UNITED STATES
NUCLEAR REGULATORY COMMISSION
WASHINGTON, D. C. 20555
February 3, 1978

INDIAN POINT NUCLEAR GENERATING UNIT NO. 3

AMENDMENT TO FACILITY OPERATING LICENSE

Amendment No. 11
License No. DPR-64

Figure 6.2-1 Facility Management and Technical Support Organization

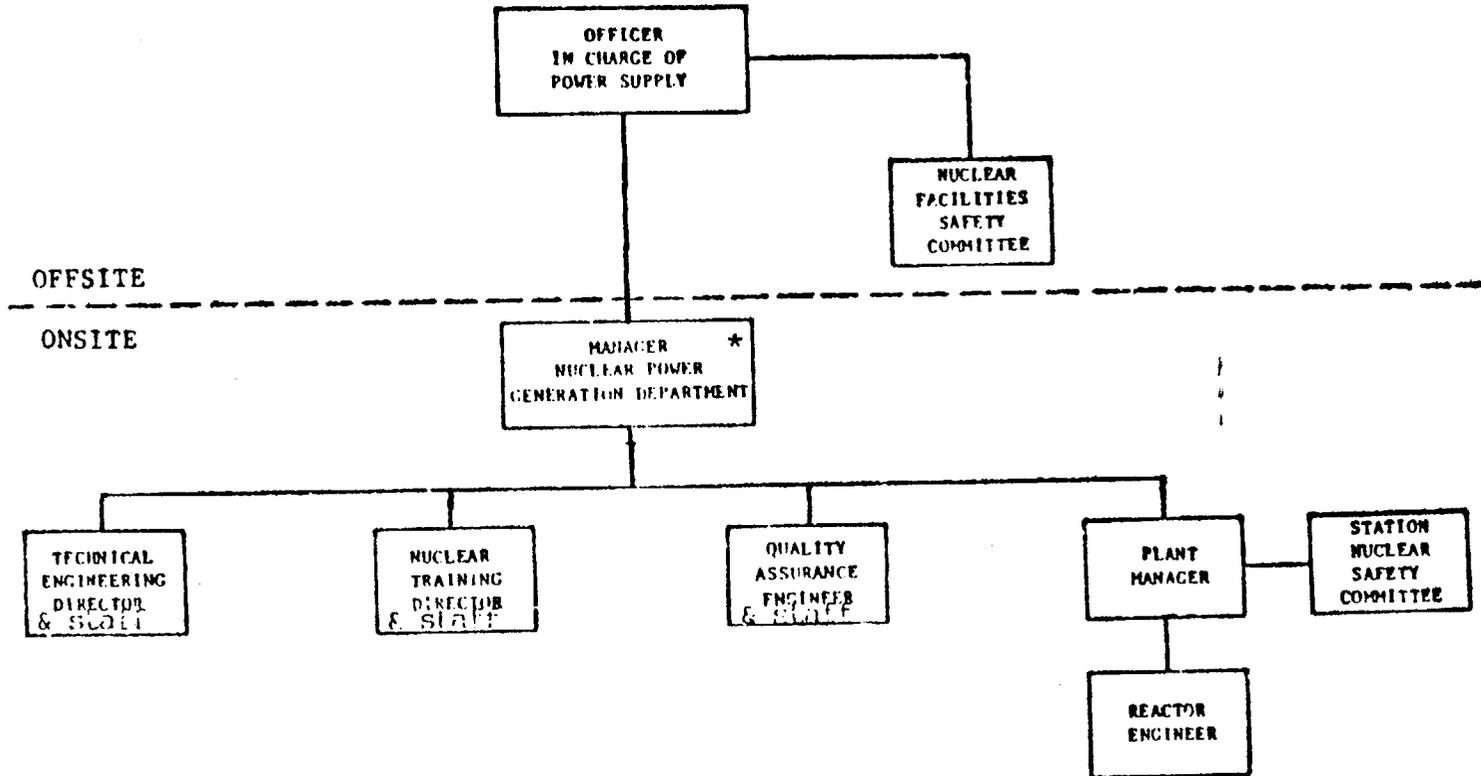
1. Change Technical Specifications to clarify Nuclear Facilities Safety Committee responsibilities;
2. Change organizational chart to reflect current organizational responsibilities to show that the Manager-Nuclear Power Generation Department would report directly to the Officer In Charge of Power Supply; and
3. For Units 2 and 3 add the Refueling Engineer as a member of the Station Nuclear Safety Committee.
